Marine
Management
Organisation

MMO Reference: DCO/2019/00005

Planning Inspectorate Reference: EN010117

**Planning Act 2008, E.On Climate and Renewables UK Ltd, Proposed Rampion 2
Offshore Wind Farm Order**

Figure 4.5 Predicted worst case behavioural response impact ranges for spawning herring from the **piling of monopile foundations** (135db SELss) for east and west modelling locations, with a 15 dB noise reduction based on DBBC.

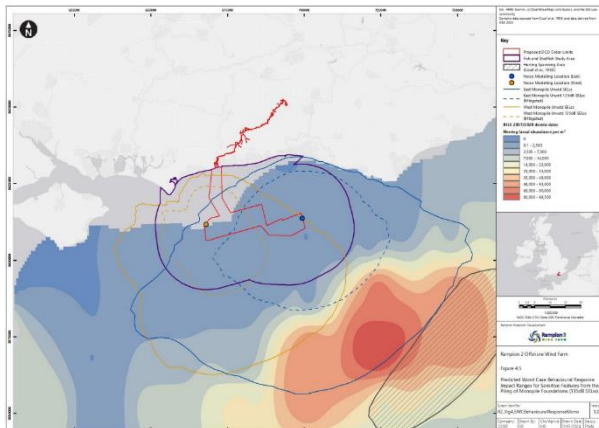
- i. All of the mitigated UWN contours modelled in relation to the herring spawning ground and the range of behavioural effects in adult spawning herring seen in recent consultations, have been based on a 15db noise abatement reduction achieved using a DBBC. Modelling for behavioural effects from piling mitigated with a 15 dB noise abatement reduction, presented in Figures 4.5 and 4.6 (included below and discussed in Section 2.14.15 of our Deadline 5 Response (REP5-146)), shows a reduced range of impact with the mitigated noise contours overlapping with areas of slightly lower larval densities (23,000 – 48,000 per m²) than the unmitigated noise contours. Taking the area where high larval densities occur (>35,000-48,000) to represent high potential herring spawning habitat where herring are likely to be engaged in spawning activity (in lieu of an adequate potential spawning habitat heatmap and recognising the limitations of the *Coull et al.*, (1998) spawning ground shapefile9), the reduced range of impact may be acceptable.

- ii. However, this is dependent upon a 15 dB noise abatement reduction, which the Applicant has indicated that based on past case studies, the effectiveness of any BBC system could decrease by 1 - 2 dB in water depths of 50 m compared to 40 m. Knowing now that approximately 30% of turbine locations will be in water depths of over 40 m, potentially between 50-55m, there is some uncertainty as to whether the modelling scenario presented is fully reflective of the real world worst-case scenario. That is to say that we have not been advised by the Applicant exactly which turbine locations are located in waters deeper than 40m and have not been presented with modelling with compares the mitigated UWN contours for a 15 dB noise abatement reduction with those of 13 dB noise abatement reduction. This is significant because, if the deep-water turbine locations are located on the east side of the array closer to the herring spawning ground, mitigated UWN contours with a 13 dB noise abatement reduction may show a larger overlap with the herring spawning ground than is indicated in Figures 4.5 and 4.6 below. That means that the potential for significant behavioural effects in spawning adult herring may be

greater as, potentially, a larger portion of the spawning ground would be affected.

Figure 3.3 provided in support of Action Point 38 in Consultation 2312, which presents 'indicative herring spawning data'.

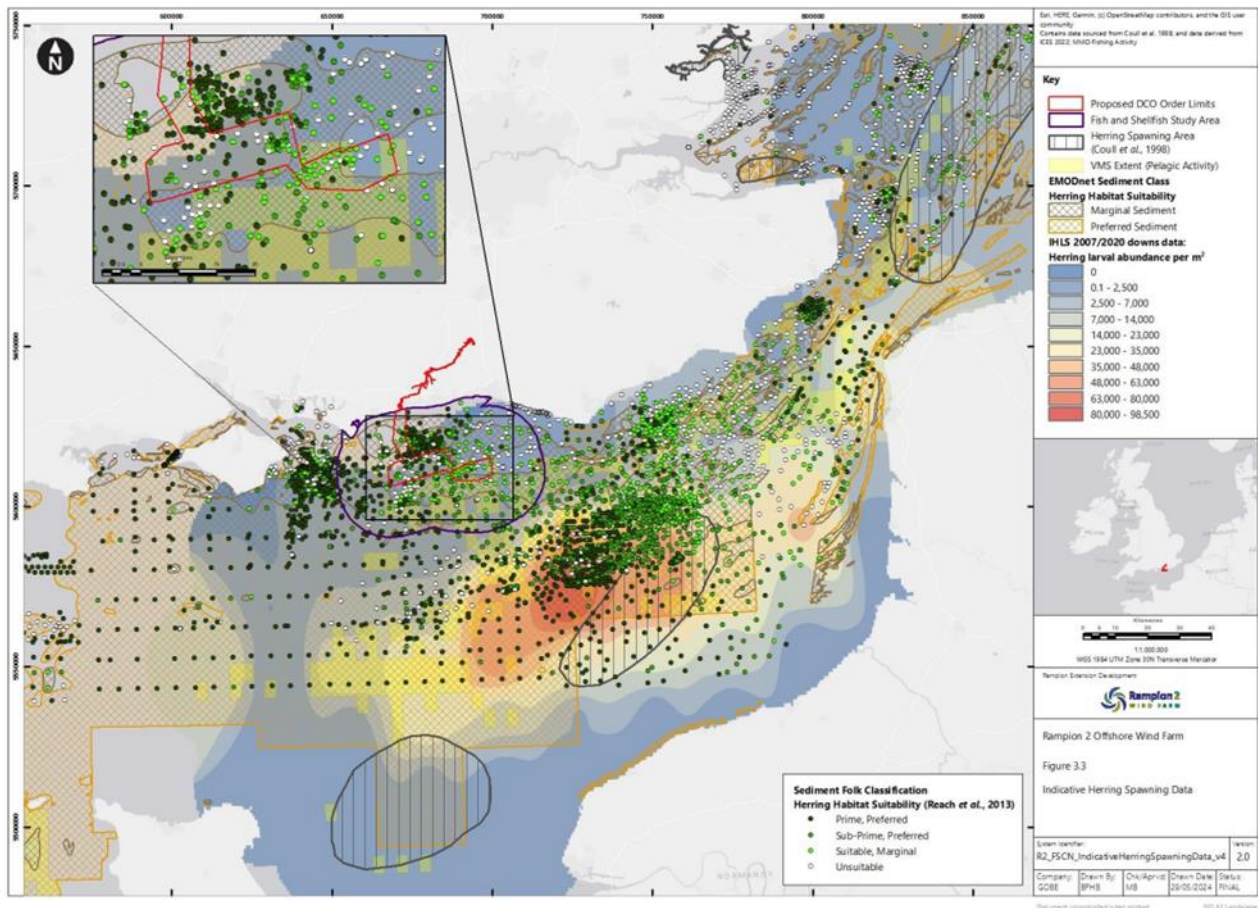
- 8.3.9 Therefore, as larvae are drifting eastwards, it follows that the larval abundances shown in Figure 3.3 (Annex 2) originated from the spawning beds where sediments have sufficient composition to support spawning, as indicated by the PSA data. It should also be noted that the IHLS data presented in Figure 3.3 presents the

Figure 5.10 Piling exclusion zone for the piling of monopiles with DBBC and another noise abatement measure (20dB reduction)

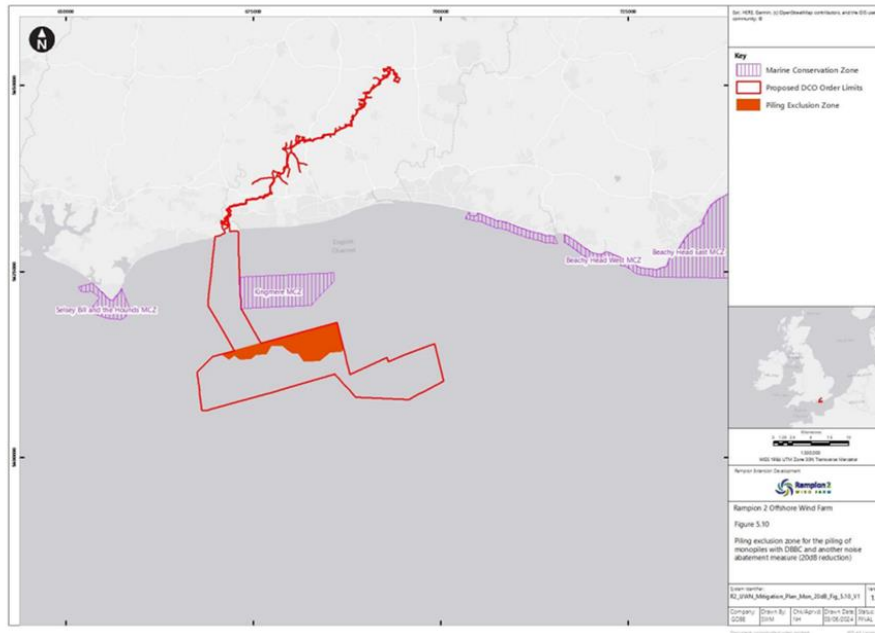
- 9.2.5 The modelling used to produce Figures 5.10 and 5.11 is based on a 141 dB threshold which the MMO and Cefas fisheries advisors do not support (please see Annex 3 for an explanatory note on why the 141 dB SELss is not supported by the MMO and Cefas). The Applicant has then used the outcomes of this modelling to support their zoning and sequencing plan for piling during the black seabream breeding period. Regardless of whether a 20 dB noise reduction is achievable, the key issue is that the modelling should have been based on a 135 dB threshold, not a 141 dB threshold. The Applicant has presented some modelling using the 135 dB threshold in Figures 5.16 and 5.17 (Annex 4) which show the predicted worst case and mitigated behavioural response impact ranges for Sensitive Features from the piling of monopile and multileg foundations. However, this modelling (in Figures 5.16 and 5.17) is based on the use of DBBC so only offers 15 dB noise reduction, not 20 dB.

Figure 5.16 Predicted Worst Case and Mitigated (DBBC) Behavioural Response Impact Ranges for Sensitive Features from the Piling of Monopile Foundations (135dB SELs)

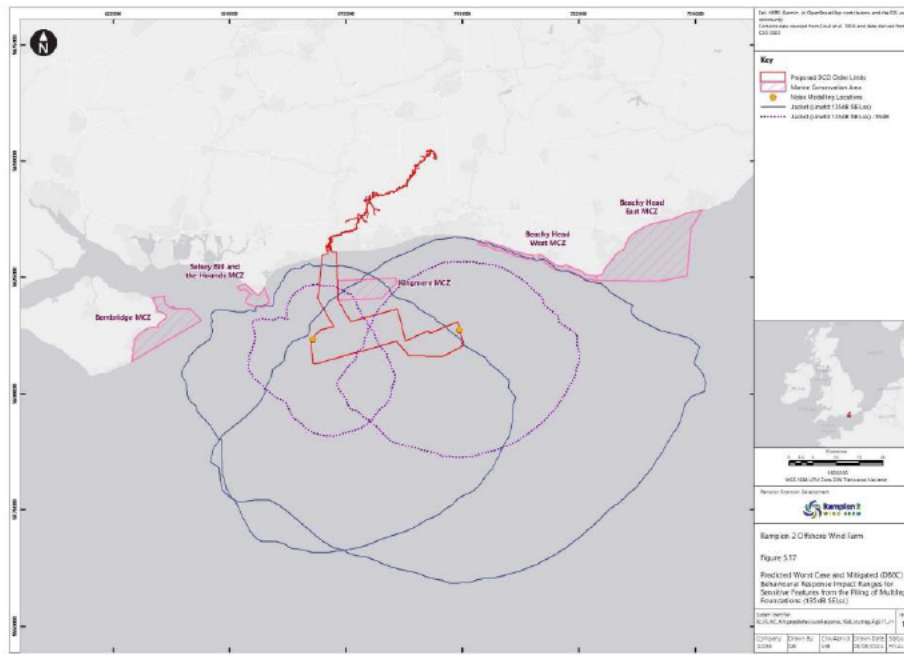
- 9.2.6 Aside from the zoning and sequencing plans being based on an unsupported threshold, it is important to note that the modelling presented in Figures 5.16 and 5.17 shows that there would still be an overlap of noise disturbance with Kingmere Marine Conservation Zone (MCZ) when mono-piling at the western modelled location, and a slight overlap of noise disturbance with Kingmere MCZ when mono-piling at the eastern modelled location. A similar result is shown in Figure 5.17 for multileg foundation piling, with an overlap of noise disturbance with the Kingmere MCZ when

piling at the western modelled location. However, at the eastern modelled location there is no direct overlap of noise disturbance with Kingmere MCZ, however, the mapped noise contour suggests that noise disturbance effects would still be received <1 km from the Kingmere MCZ boundary. If the modelling in Figures 5.16 and 5.17 had been based on a 20 dB noise reduction, then we would be in a stronger position to comment, but as it hasn't, significant uncertainty remains.

9.2.12 The Applicant directs the MMO to Figures 5.16 and 5.17 of the revised In Principle Sensitive Features Mitigation Plan (REP5-083) and highlights that no unmitigated piling will be undertaken during the piling campaign. As per points 31 – 33, Figures 5.16 and 5.17 demonstrate that piling noise from mono- and multileg foundation piling will overlap Kingmere MCZ with or without noise abatement of -15 dB, rather than the 20 dB that is now proposed by the Applicant. The Applicant's response also highlights the proposed implementation of a seasonal piling restriction in the western portion of the array from March to June, and multiple measures during the month of July.

Figure 2-5: Zoning plan restriction areas

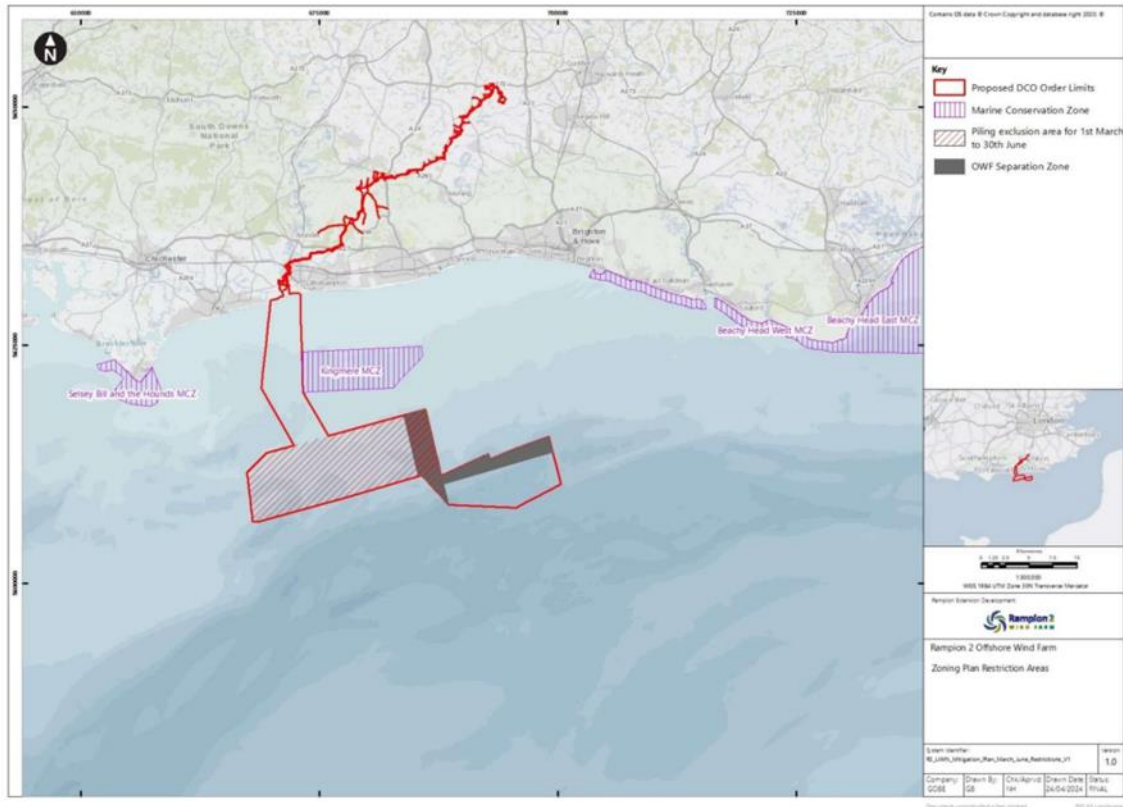
9.2.10 The MMO will also highlight that the Applicant's zoning plan in Figure 2-5 (Appendix H) and Figure 5.12 (REP5-083) proposes a piling exclusion zone from 1st March to 30th June, although the MMO have consistently advised that the black seabream breeding season is from 1st March to 31st July inclusive. Further, the Applicant has set out a zoning plan for piling during July in Figure 5.13 (In-Principle Sensitive Features Mitigation Plan) and Figure 2-6 (Appendix H). For the reasons outlined in Sections 9.2.5 above and 9.2.12-9.2.13 below of this Deadline Response, the MMO do not currently support the proposed zoning and sequencing plan, but even if such a plan was to be accepted, it must be based on the period 1st March to 31st July inclusive.
